ADDENDUM NUMBER 1

NOTIFICATION DATE:	BID TITLE:	BID NUMBER:	BID OPENING DATE & TIME:
4/04/12	City of Naples – Sidewalk Installation River Park	033/12	04/09/12 2:00PM

**CROSS-SECTION
B-B**

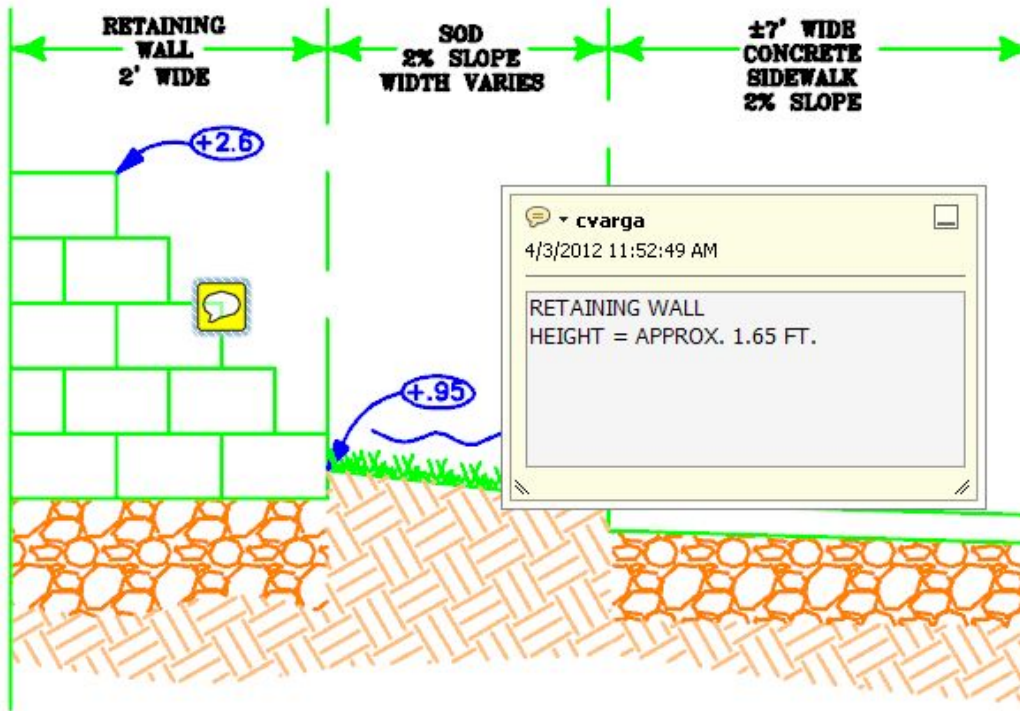
1. In review of the plans there is no detail of the construction of the retaining wall can the City provide a detail?

Attached

HEIGHT: 1.65 FT
LENGTH: 35 FT
WIDTH: 2 FT

THIRD AVENUE NORTH SIDEWALK GRADING PLAN

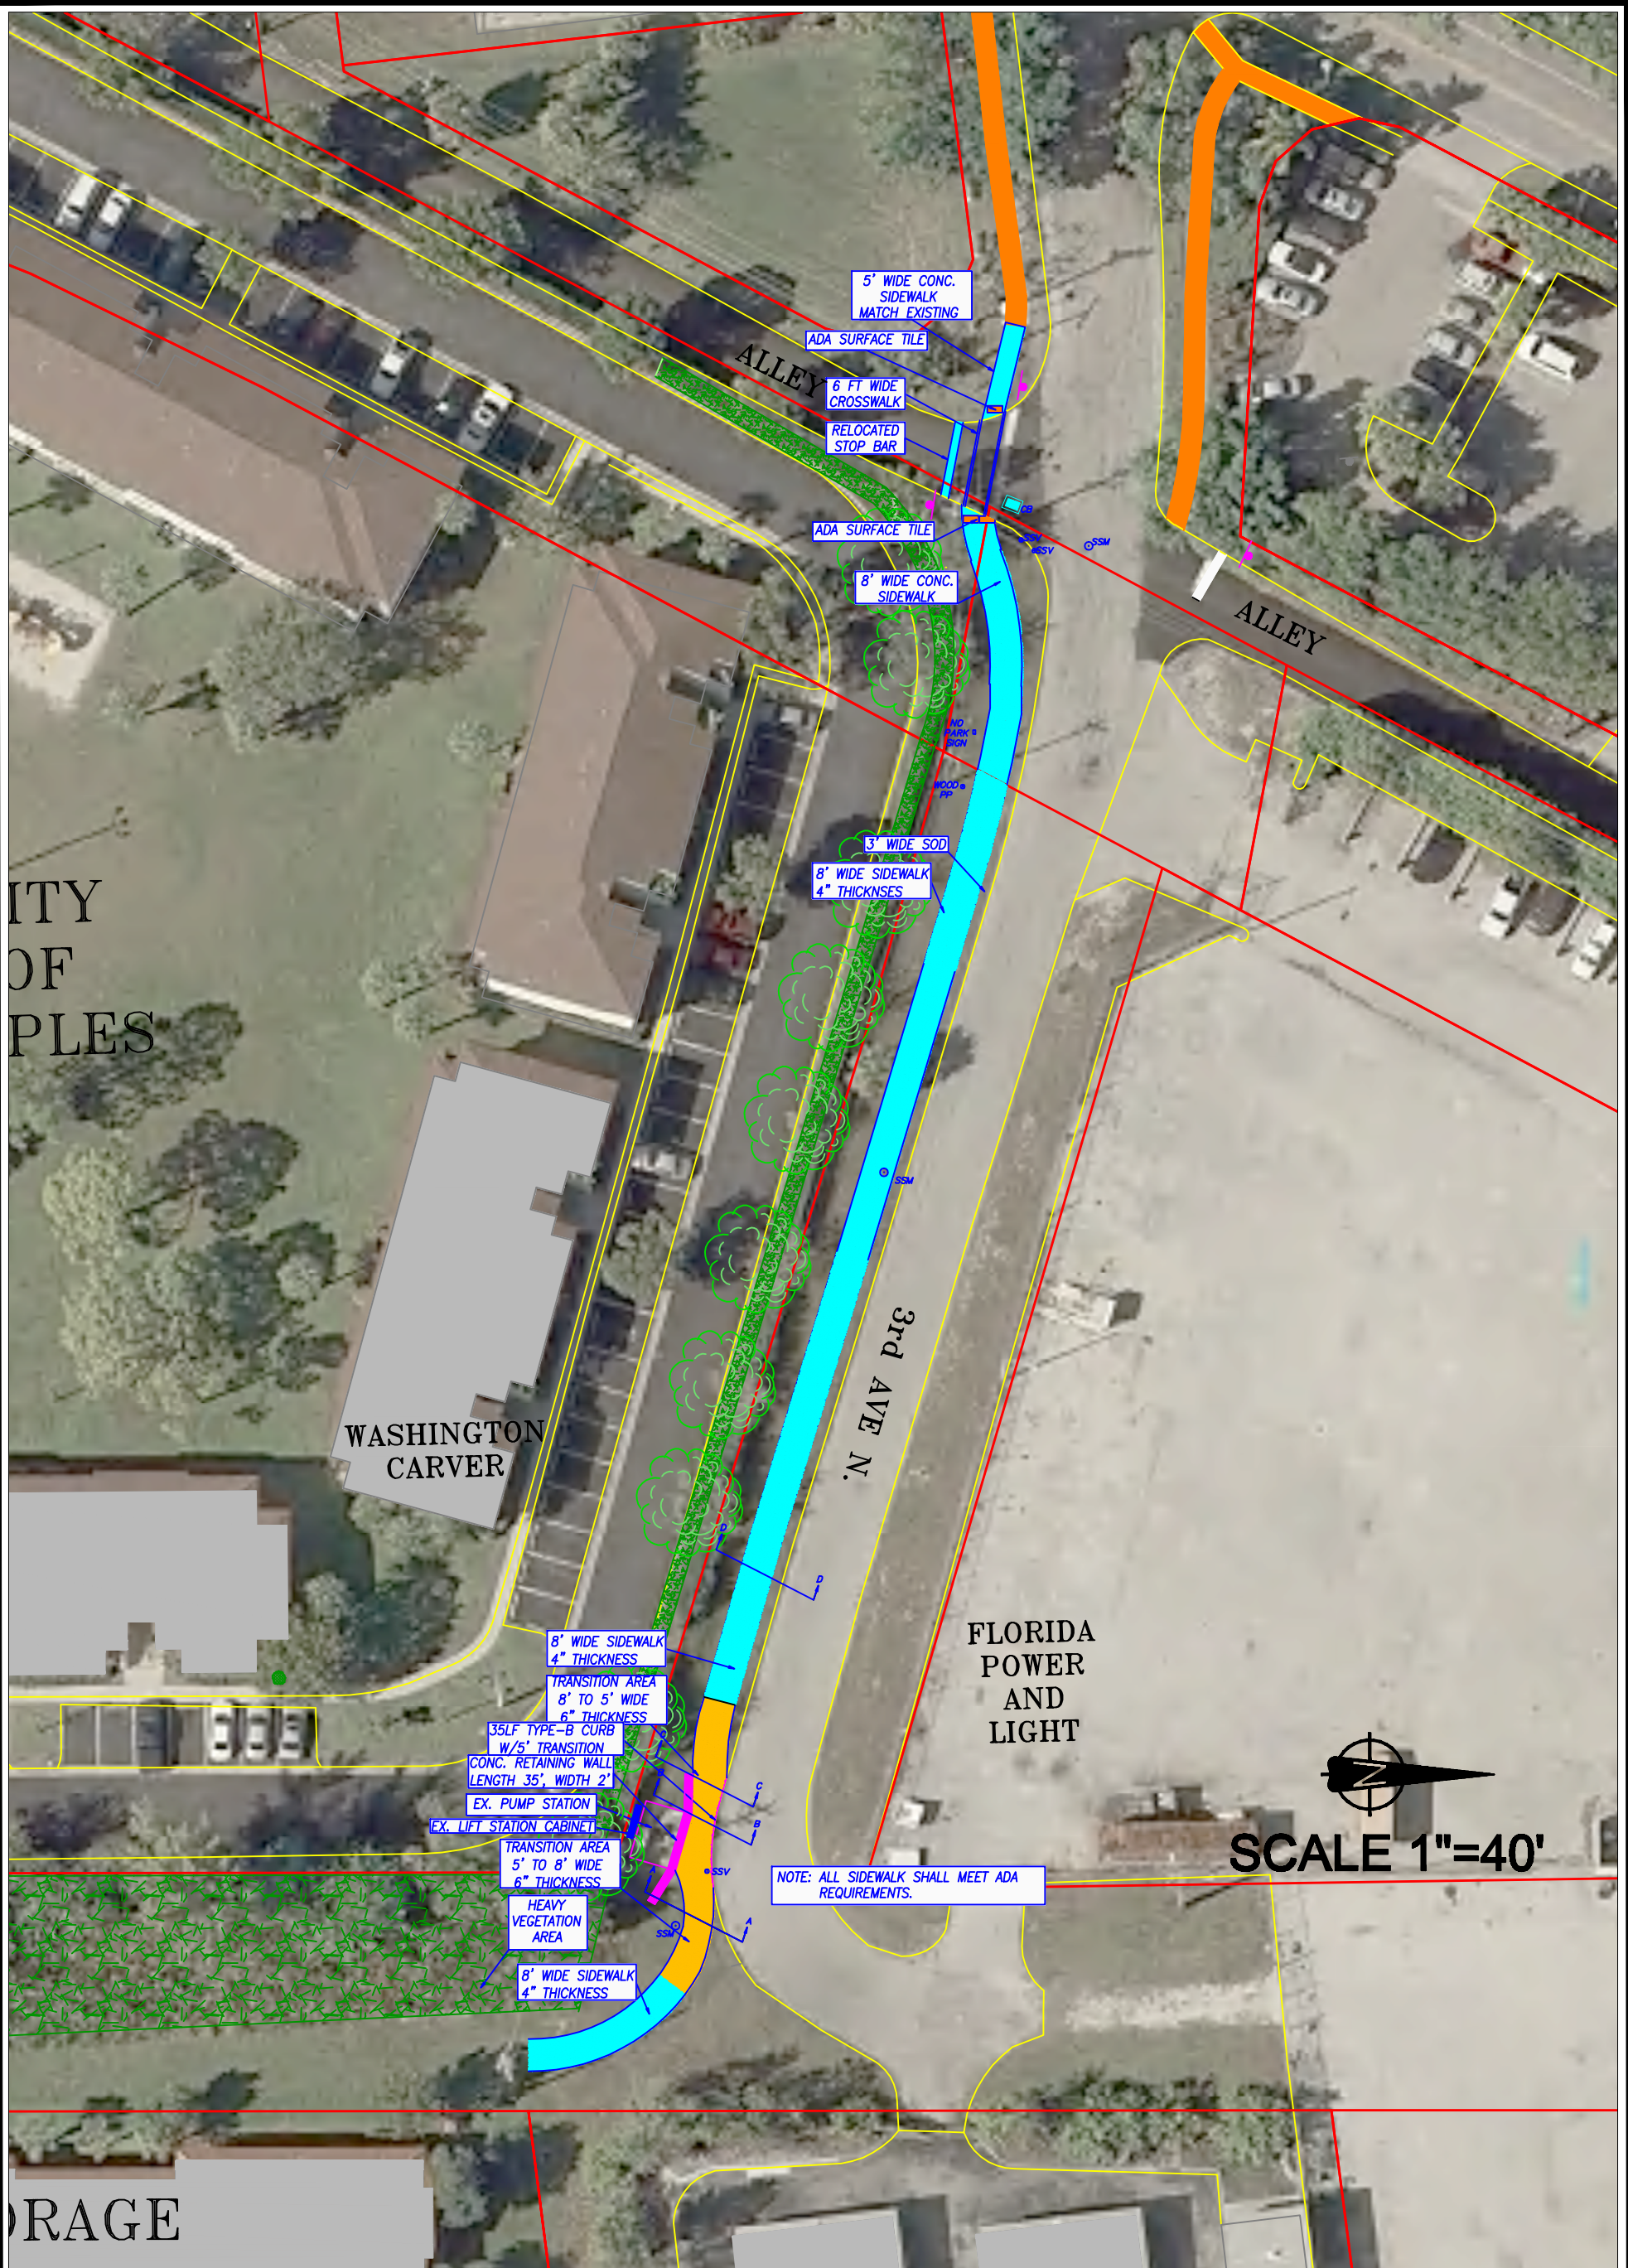
3. As per note 2 on the Grading Plan. Can all the material excavated be placed along 12th street?

8. Will the excess material be going to 12th St North ROW that is adjacent to this project?

Yes, with placement subject to direction of engineer provided that the material is acceptable.

Disposal of the excavated material shall be by placement along the west side of the unimproved portion of the 12th Street corridor extending southerly from the City's sewer pump station an approximate distance of 150 feet, more or less, with a nominal width between 10'-15', a height of up to 12" above existing grade and subject to direction of the Project Engineer.
